# XAUI

## Clause 47

# Portland Goals

- Resolve 28 comments against D3.1, equally split between TR, T and E.
- Make technical *changes* now where the issue is important and the information is solid.
- Can make further technical changes in Sponsor Ballot. Make *plans* now to have needed technical information by Sept. Interim.

# Return Loss - Differential

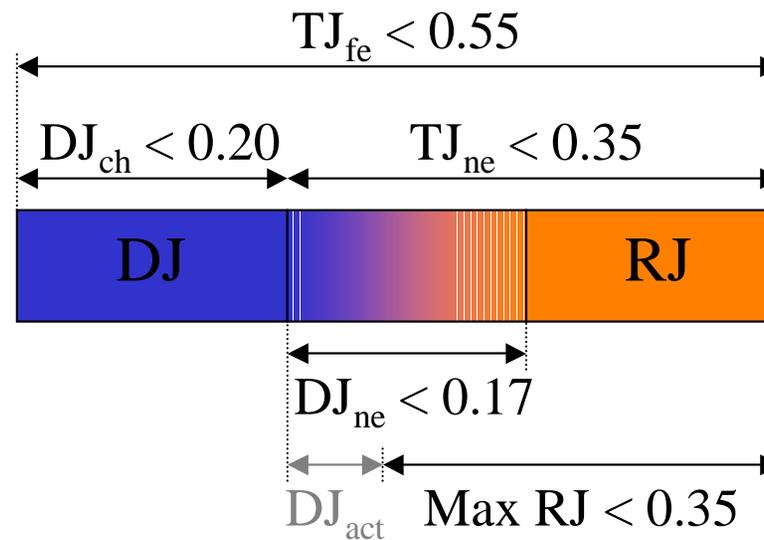
- Presently spec'ed at 10 dB from 100 MHz to 2.5 GHz for driver and receiver.
- Simple RC model suggests this will be a problem for practical drivers with ESD protection.
- No solid measurement results or simulations presented yet. (What can be achieved?)
- No detailed system study presented yet. (What can be tolerated?)

# Maximum RJ

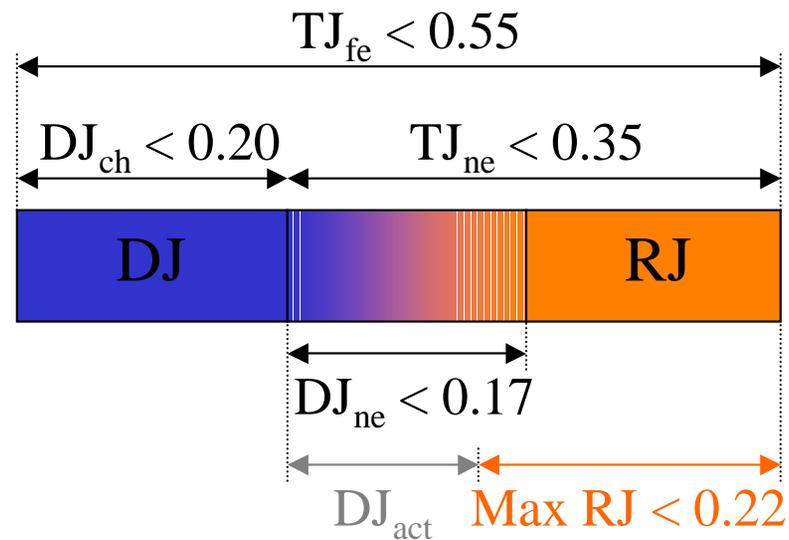
- Presently only limited by  $TJ_{\max} - DJ_{\text{actual}}$ .
- An upper limit on RJ could ease timing recovery requirements.

# Maximum RJ

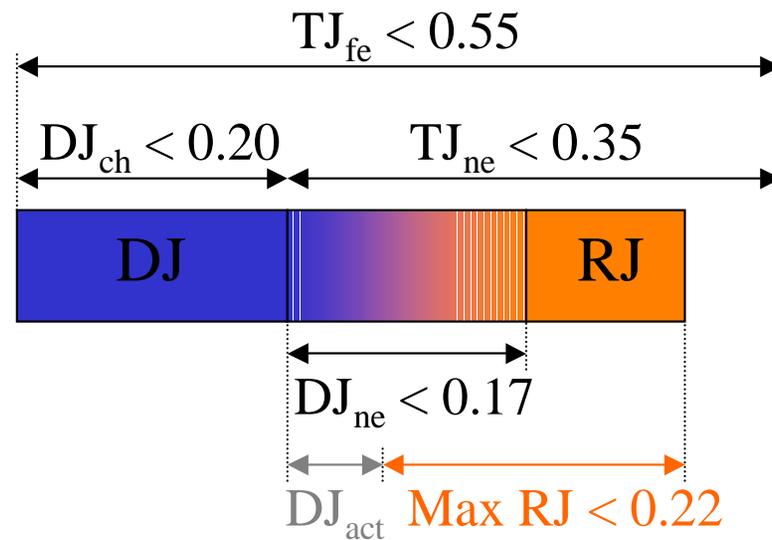
- Presently only limited by  $TJ_{\max} - DJ_{\text{actual}}$ .
- An upper limit on RJ could ease timing recovery requirements.

# Maximum Input Amplitude

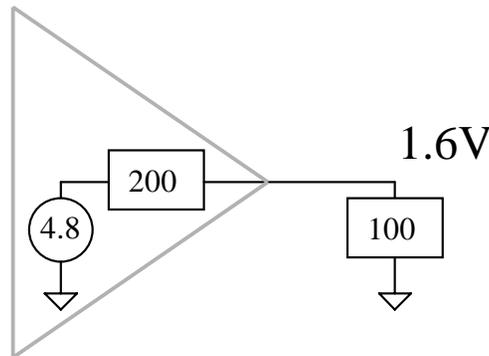
- Severe example: Driver impedance at 1.56 GHz is 200 ohms with no reactive component.
- Thevenin equivalent source voltage is 4.8Vpp at 1.56 GHz (1010 pattern).

# Maximum Input Amplitude

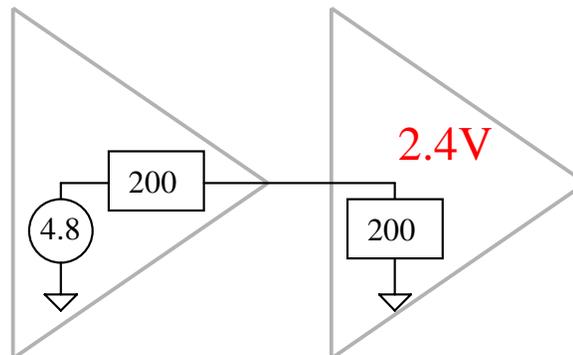
- Severe example: Receiver impedance is the same as the driver.
- Resulting receive signal is 2.4Vpp.

# Compliance Channel Review

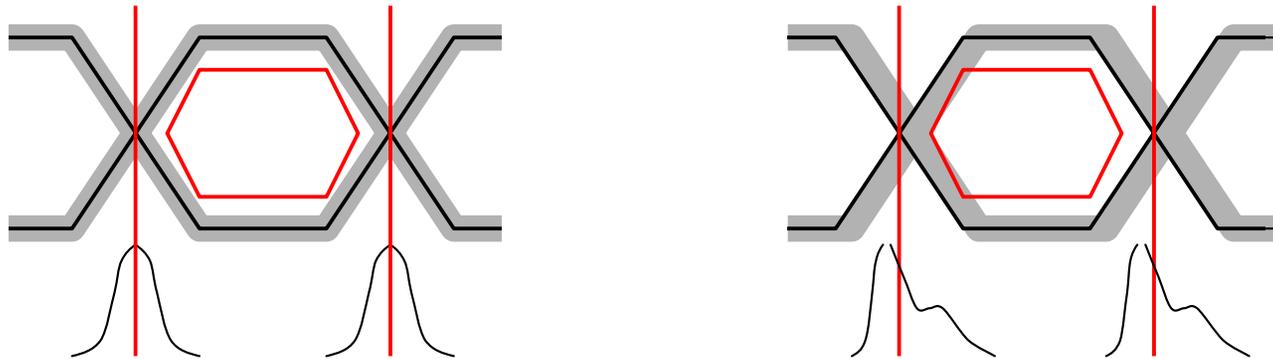
- Initial efforts to define physical channels (both PCBs and filters) were unsuccessful. The affects of the material and manufacturing variations of physical systems are too great at the high frequencies important to XAUI.
